Urbana Residential Phase 1 Inspection Report

Inspection Date : 28th June

IDEAL DRAINAGE CONDITIONS

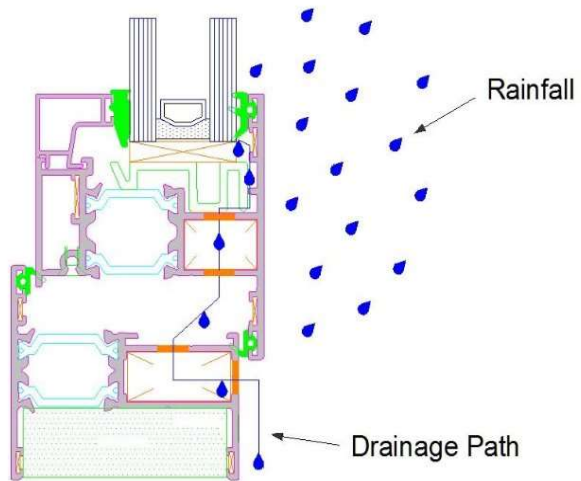
- The collected water in the track should be drained from the holes drilled in sliding and casement windows.
- The track also must have its own water holding capacity in it.
- The draining capacity determines the volume of water the window can handle and drain the same.
- For sliding windows, the track should be clean to maintain holding capacity and avoid blockage of drain holes.

EVIDENCE OF SEEPAGE THROUGH SLIDING WINDOW

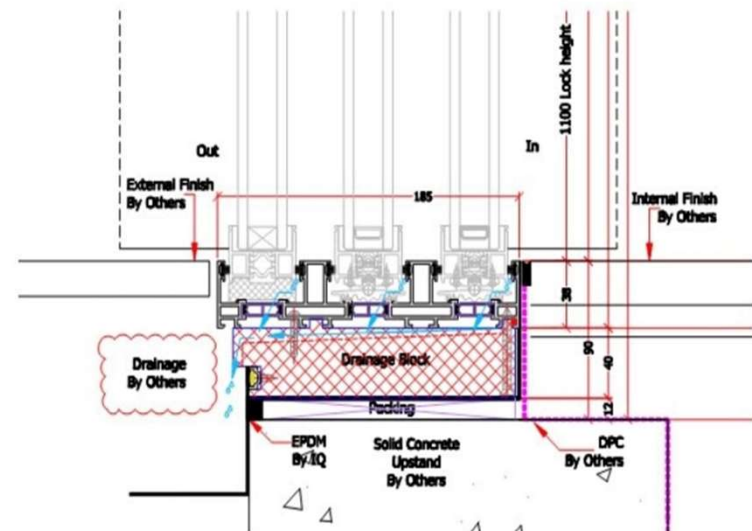
- Majority of the cases due to rainwater entering through the sliding windows are not leakage but water spillage due to bubble effect created due to pressure difference. This effect happens occasionally due to difference of Temperature and wind turbulations. During certain days of year due to wind and temp difference the pressure outside the building is marginally more than the indoor pressure .
- Periodical servicing and maintenance deficiency.
- However, observed some wear and tear on certain windows, particularly those that had been exposed to harsh weather conditions over the years. This natural weathering had likely contributed to the minor issues experienced during the heavy rain.
- Improper alignment of window shutters due to operational deficiency.

- Additional drainage points to be created in fixed windows along with fixing of NRV valves.
- Additional drain caps to be installed.
- Incorporate 'End Dam' to increase water retaining capacity, where it is missing.
- Periodical servicing of the windows required like shutters, locks etc., so that alignment is proper.
- Proper and timely cleaning of window channels.
